PHOTOGRAPH #20

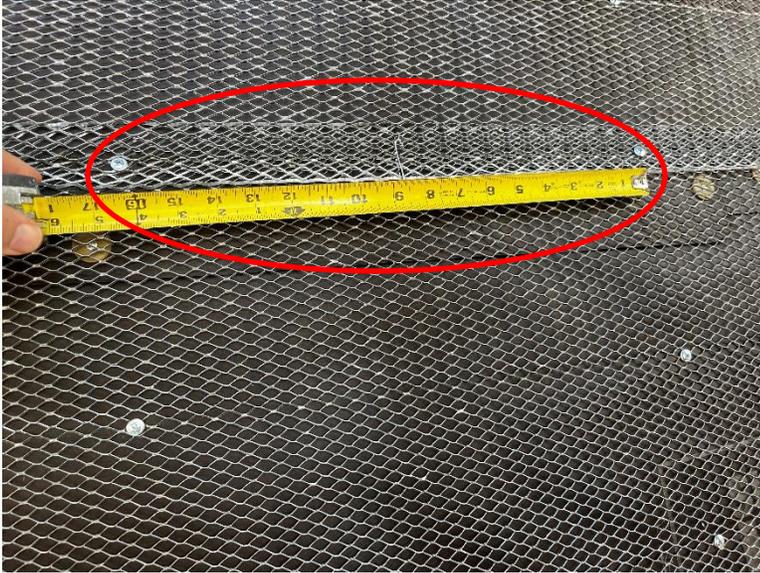
Vinyl stucco accessories and galvanized metal lathing inspected and approved to receive 3 coat stucco applications.

PHOTOGRAPH #21

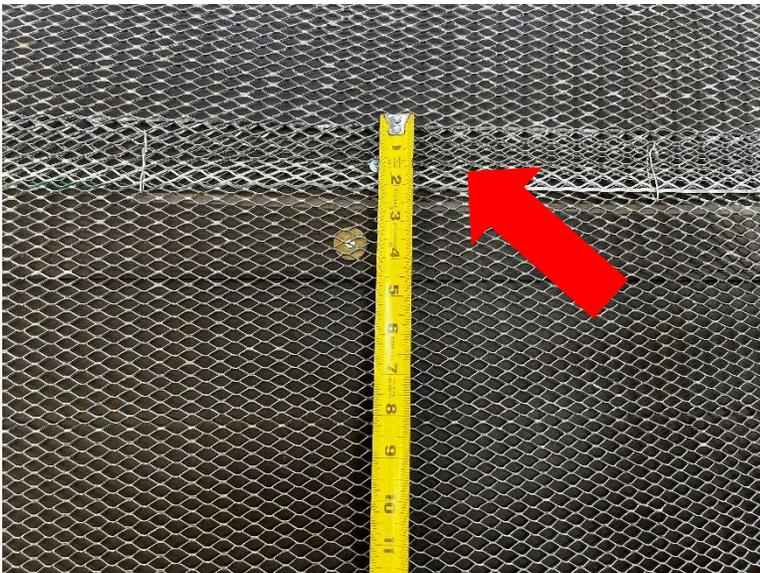
Galvanized lath fastened at framing 16" O.C. and wired together at intervals no more than 9" O.C. as per ASTM C1063.
